12-BSTD-1

April 10, 2012

Re: March 13, 2012 45-day Language Hearing for Residential Buildings - 2013 Building Energy Efficiency Standards (AHRI Comments on Residential Zoned Air Conditioning; Docket # 12-BSTD-1)

### **Slide 15 – Research on Multi-Zoned Systems**

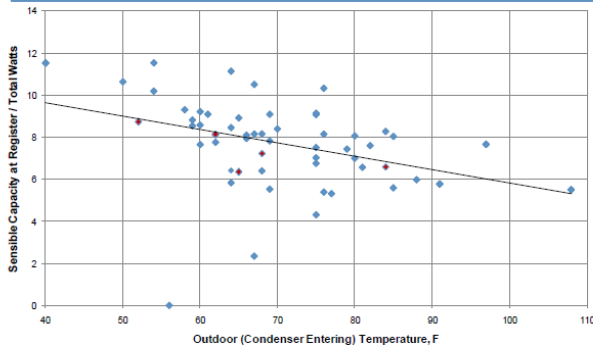
These separate research projects both came to the same conclusions, zoning can add 20% (not the 35% as noted on this slide\*) to energy costs if no setback is used and can provide 25% savings when setback is used. Attached is another chart from a more recent study on zoning showing a 30% reduction in cooling KWH with zoning. The presenters continue to report only on the increase in energy and not on the savings.

Figure 1

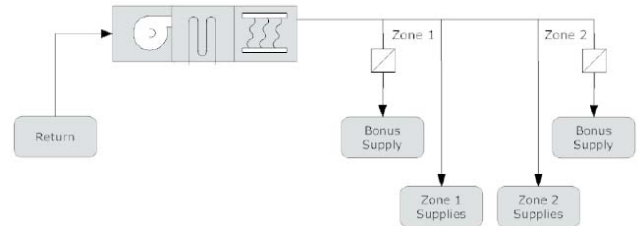
- Two large zones minimum excess air, so this is the best scenario for simple single-speed equipment.
- Two large zones (minimum excess air) require less air relief measures, which may be some combination of bypass air, a dump zone, damper stops, and zone over blow.
- The slides only mention bypass air and over blow, and propose to ban bypass air.
- The Slide 21 solution (Figure 1) shows a duct system that has an undamped supply to each zone, and a damped supply to each zone. There is no simple way to predict the behavior of this design.

*A zone may not need supply air, but some undetermined amount of supply air will be delivered to the zone (through the undamped supply) when the zone damper is closed.*

*In general, how can practitioners be sure that the proposed (Figure 1) design will always deliver adequate performance for any operating condition?*

### **6.6 Duct Efficiency Comment**

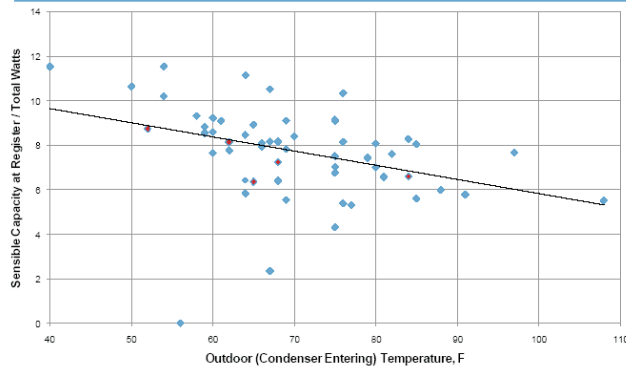
Not sure what MF duct leakage means and what SF means, but the industry knows that duct system efficiency has a significant affect on comfort, equipment performance, energy use, and operating cost.

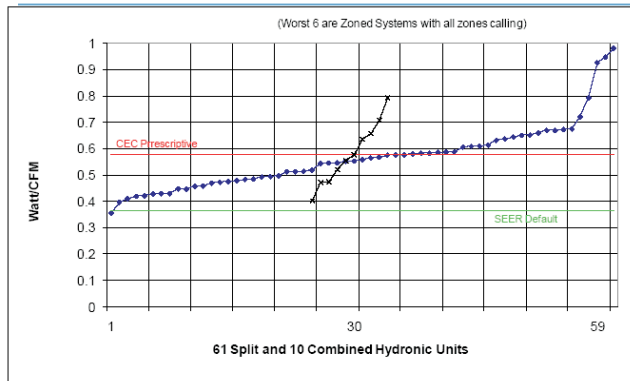
These tests may not be sensitive to equipment installation issues. Was the central equipment correctly sized or oversized? Was Cfm per nominal AHRI ton equivalent for one zone and multizone tests? Is refrigerant charge correct for one zone and multizone tests?

These tests do not seem to be apples-to-apples, as far as the issues that affect momentary system efficiency are concerned. And, the presentation implies that momentary efficiency is equivalent to seasonal efficiency.

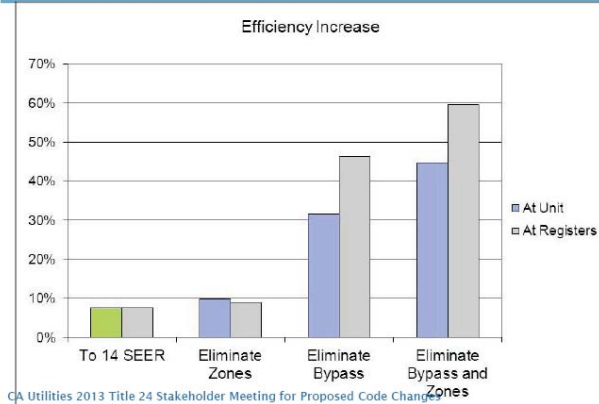
If this slide is consistent with Slide 8 (Sensible Capacity at the Register), EER is defined as supply air Btuh divided by system KW. **See Section 8.1 for comments on this practice.**

All the comments for Slides 8, 9, 10, 12 and 15 apply here.

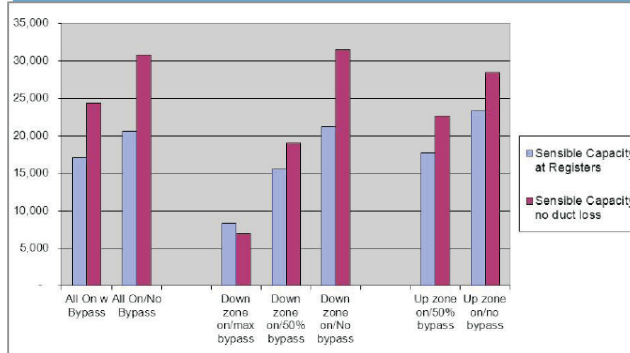
- n How is efficiency defined.  
*Seasonal or momentary?*  
*At unit = Total Btuh out / KW in?*  
*At registers = Sensible Btuh out / KW to unit?*
- n What does "To 14 SEER" mean? Is this the base case (single zone unit)?
- n Wouldn't eliminating zones automatically eliminate Bypass?
- n Do not know enough about the graph to comment.

## Slide 21

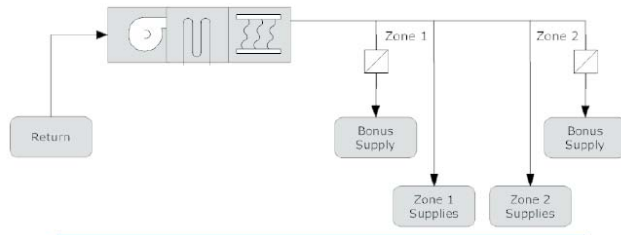
The Slide 21 solution (Figure 1) shows a duct system that has an undampered supply to each zone, and a dampered supply to each zone. There is no simple way to predict the behavior of this design.

- n Air outlet performance (throw and noise) depends on make, model and size. Some guidance is needed here.
- n In general, how can practitioners be sure that the proposed (Figure 1) design will always deliver adequate performance for any operating condition?
